Omaha Public Power District
444 South 16th Street Mall
Omaha, Nebraska 68102-2247
402/636-2000

April 23, 1992
LIC-92-011R

SUBJECT: Additional Information on Main Steam Safety Valve (MSSV) Setpoint Drift

FIGURE B
PRIMARY SAFETY VALVE CHARACTERISTICS

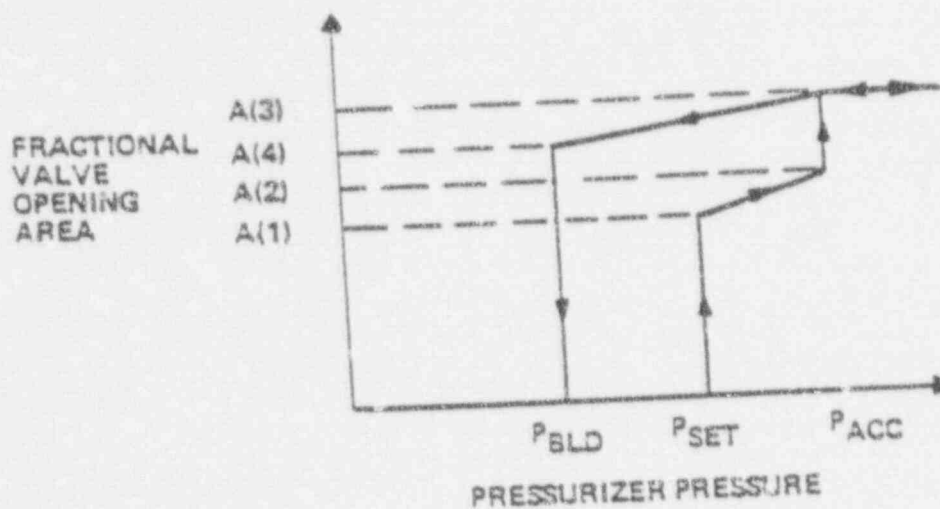
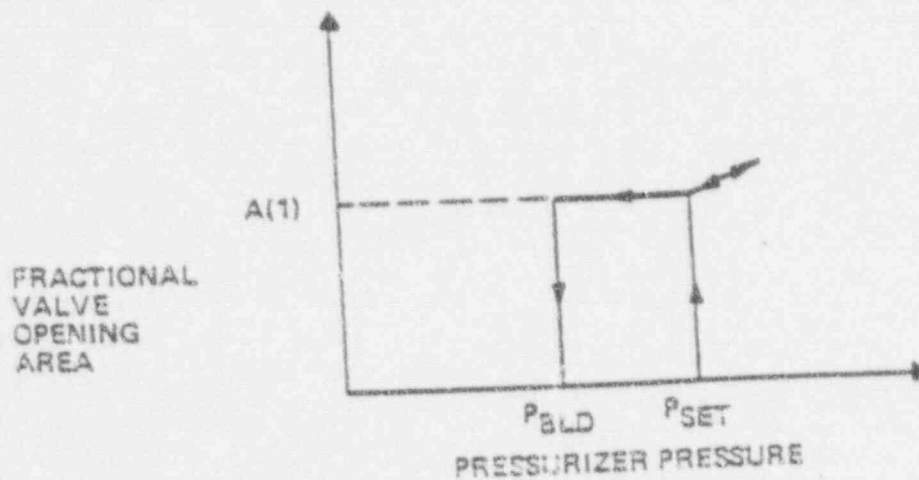
NRC Request #2: How are the PSVs modeled for Fort Calhoun Station? What are the actual values for the various input parameters?

OPPD Response #2: The PSV accumulation and blowdown characteristics are shown on the attached Figure B, Rev. 1 (CESEC Code Version 88120). This revision supplements the Figure B (from CESEC Code Version 85055) provided with Reference 4. For Fort Calhoun Station, the P_{set} and P_{acc} values are both modeled as 2525 psia. The A(1), A(2) and A(3) values are all modeled as 1.0, and the A(4) value is 0.7, in accordance with the manufacturer's recommendation for expected safety valve operation. An EG&G Idaho, Inc. valve test program (EGG-NTA-7634 Rev. 1) determined that the PSV has an opening time of 4 - 5 milliseconds. This prompt opening time would have a minor impact on the peak reactor coolant system (RCS) pressure and no effect on the peak secondary pressure (as evidenced by the loss of feedwater event cases 4 and 5 discussed above).
